**From:** Hockenhull, Joel [<mailto:Joel.Hockenhull@balfourbeatty.com>]  
**Sent:** 23 July 2019 11:27  
**To:** Robert Wilson; Blair, Ruth; Brace, Carl  
**Cc:** 'Toby Coombes'; Horsley, Kelly  
**Subject:** RE: 16.20.011 (D) gorsley 182139 and 191593 - Drainage Comments

DESCRIPTION  
BELOW GROUND DRAINAGE GENERAL ARRANGEMENT

CONTRACT  
CHAPEL LANE GORSLEY

DRAWING STATUS PRELIMINARY		REF. SCHEDULE NOS. —	
SCALE AT A1 1:200	SCALE AT A3 1/2 SHOWN	DRAWN BY RW	CHECKED BY RW
DATE 14.09.17	CONTRACT REF. 12050	DWG. NO. 500	REV. P3

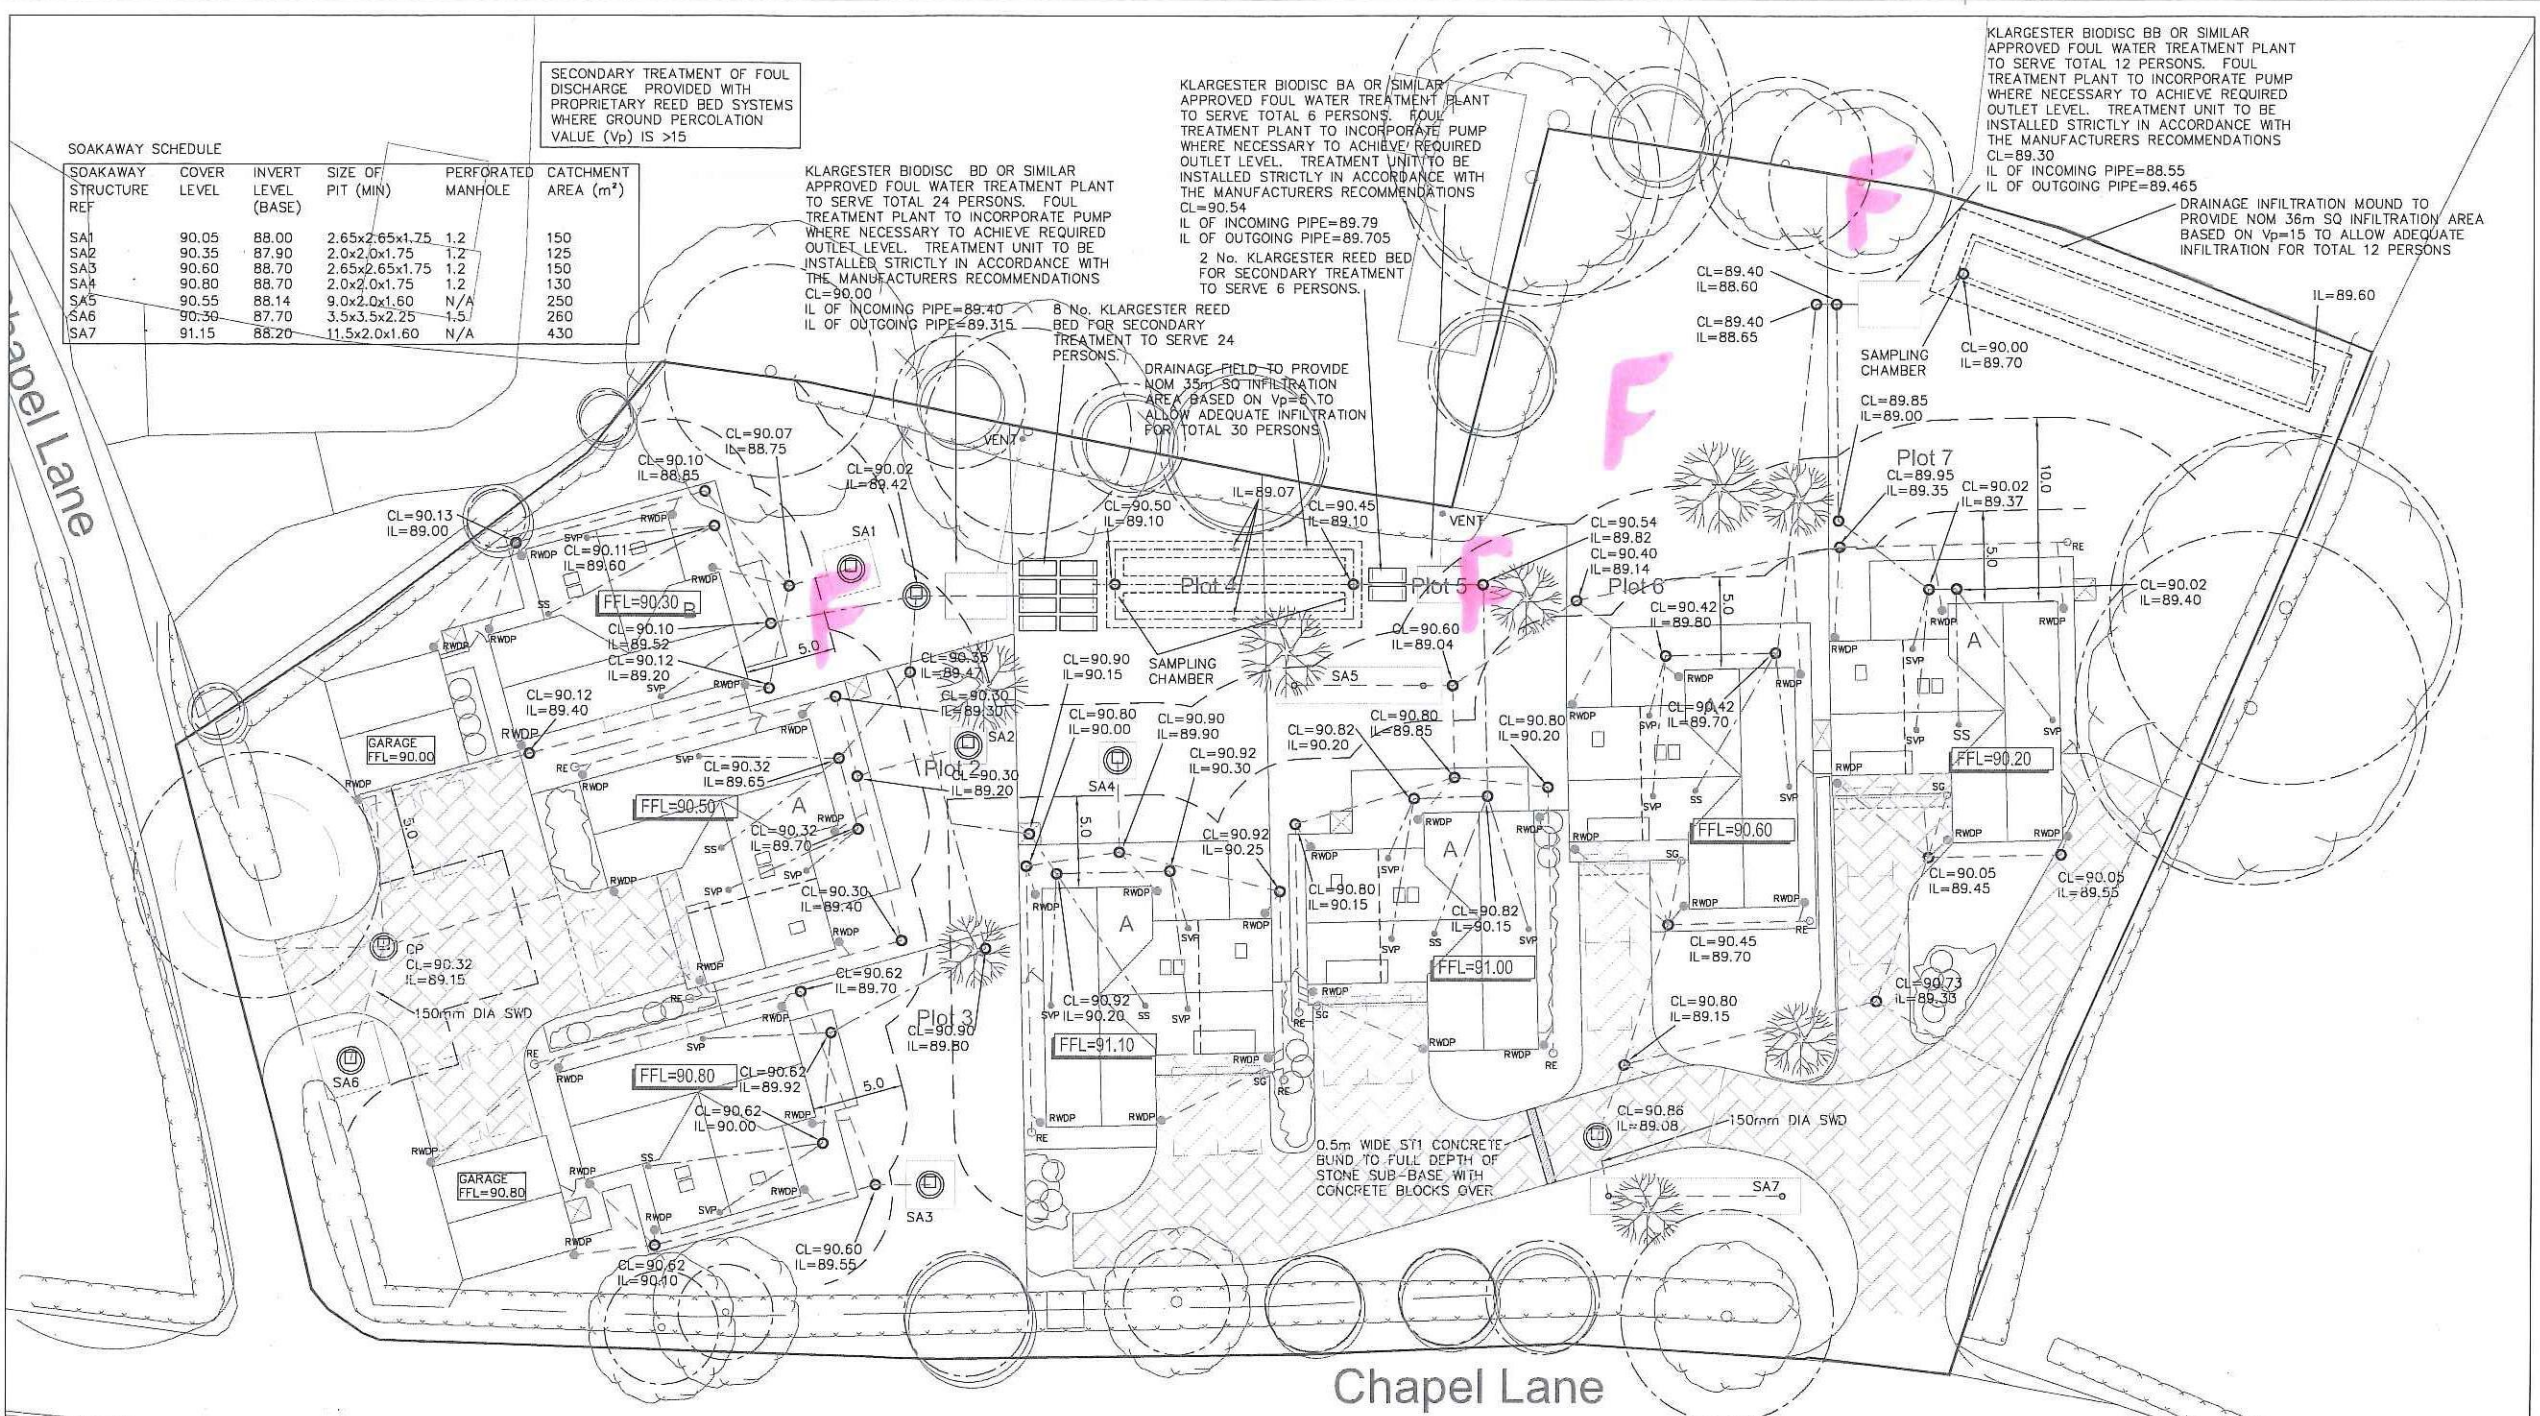
I have reviewed one of the layout drawings and established the locations where sewage would cause flooding (see attached marked up plan). In the event of pump failure, the residents at the three properties to the west of the plot would continue to use their domestic appliances, baths and WCs. The property at FFL 90.8m may continue to discharge water even in the event of being advised that the pumps had failed. Consequently the foul flooding problem would only worsen throughout a pump failure episode. The sewage would not be treated. I have not reviewed the other site but expect that a similar problem would occur there too. Water would also drain off the site affecting neighbours.

BS 6297 part 6.2 identifies that where the Vp value is between 1 and 15, the regulator should be consulted to identify options for disposal. The Building Regulations pre-date BS 6297 and do not offer the option of obtaining approval from a regulator, in the time between these guidance notes being issued Package Treatment Plants have become more extensively used.

As it stands, we would regard the current proposals regarding foul drainage to be unsatisfactory

- It appears to be accepted within your first two paragraphs that drainage mounds are appropriate for plots 1-4 however pumping 'should' be avoided. The area available and, high but variable percolation values confirm the suitability of the drainage mound – providing suitable percolation. It is accepted that a this will require a proprietary pump discharge to allow

an elevated discharge which would be expected with an drainage mound specified in accordance with Building Regulations. I understand, however pumping must be avoided where possible. We consider it more sustainable to remove the highly permeable soil and replace with suitable soil to allow for tertiary treatment. Alternatively, the use of reed beds should be investigated. We would not accept pumping where other options (as mentioned) are available.

- The drainage mound will provide the tertiary water treatment necessary and is considered more reliable. Good, however the options as mentioned above should be investigated as pumping should be avoided.
- Plots 5-7 will follow the same approach as the above and as such considered suitable.
- The requirement of an environmental permit is noted – this will be arranged by the Client. Great.
- The available area of soft landscaping and variable ground characteristics will prevent opportunity for individual treatment plants. Noted, thank you for clarifying.

We understand your reservations with regards to pumping of water however can confirm that alternative gravity options have been investigated and discounted. The constraints of the site and requirements have rendered a pumped discharge from the treatment plant as the most viable option. As your aware, drainage mounds are accepted by Building Regulations (Part H diag 2) which, may require the perforated pipes to be located above natural/adjacent ground level. Pumping stations are also permitted within section 2. As discussed please also note;

- The treatment plant will serve multiple properties and therefore ongoing maintenance contract will be required.
- A sampling chamber is located for testing of the discharged flows.
- Foul water is conveyed by gravity to the treatment plant, the discharged water only will require pumping (therefore no solids – reduced risk of pump failure).
- The treatment plants will require power to operate. (These can be also be supplied with the pumps installed).
- The drainage mound has been specified due to the ground conditions. The mound will also provide opportunity for tertiary treatment.
